DRI REGIONAL REVIEW FINDING

RE: Development of Regional Impact (DRI) Review

Name of Proposal: 2024 Avon-Higgins Mixed Use DRI 4330

DR2.0

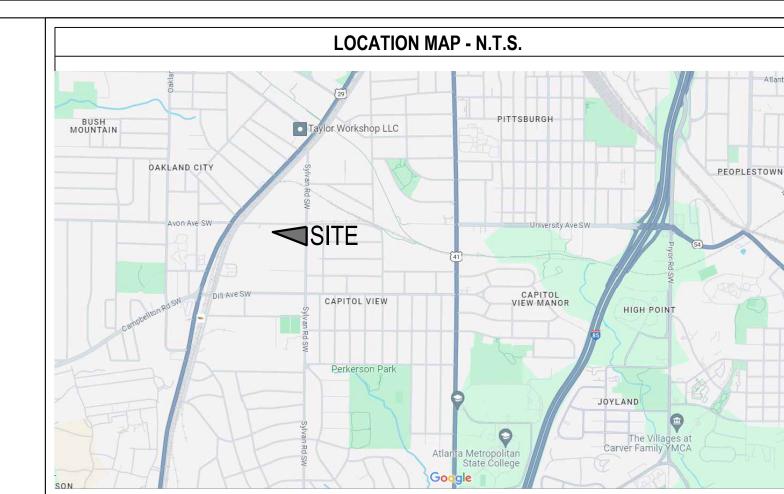
- 1. Detail connectivity between the site and the Beltline on the Site Plan. The Site Plan says that Driveway F will connect to the Beltline in the future and currently shows fencing between the property and the Beltline. Can the connection between the site and the Beltline be incorporated into current plans? What other connection points besides Driveway F are proposed?
- 2. Add "provide multiple ADA-accessible public access routes within property to the Beltline" (or something similar) to Recommendations proposed to be completed as part of the project in section H.1 on Page 38 of Traffic Impact Study.
